Edenfield Community Neighbourhood Forum

Response to Consultation about Planning Application 2023/0396

Land at Blackburn Road and Land at Burnley Road, Edenfield

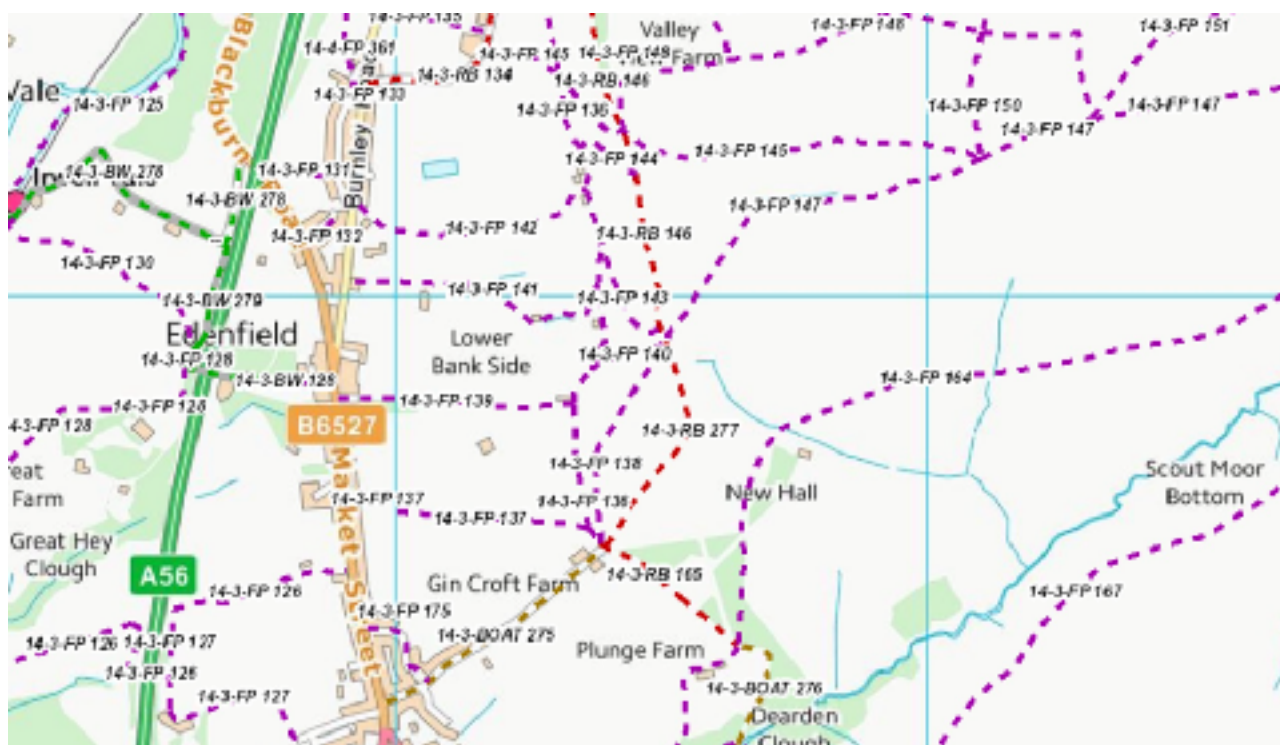
Paragraph 2.6 is wrong to claim that PROW FP 142 “stretches across the northern boundary” of Parcel 2 (east of Burnley Road). FP 142 is so far from Parcel 2 that it is not shown on Figures (2.1), (5.2) or (5.3) in the Planning Statement or the Location Plan EF01-P-LP-101. It actually runs in a generally easterly direction from a point on Burnley Road between Elton Croft and Highfield House (40 Burnley Road). Another PROW, FP 141, runs generally eastwards from Burnley Road, commencing adjacent to no 38 as shown on those Figures, but it is not close to the red edge of Parcel 2. Despite their numbers, 38 and 40 are some distance apart, separated by Elton Banks (Grade II-listed) and Elton Croft. The course of FP 141 and FP 142 is shown in Figure (2.2). Please refer to the map below of local PROW.
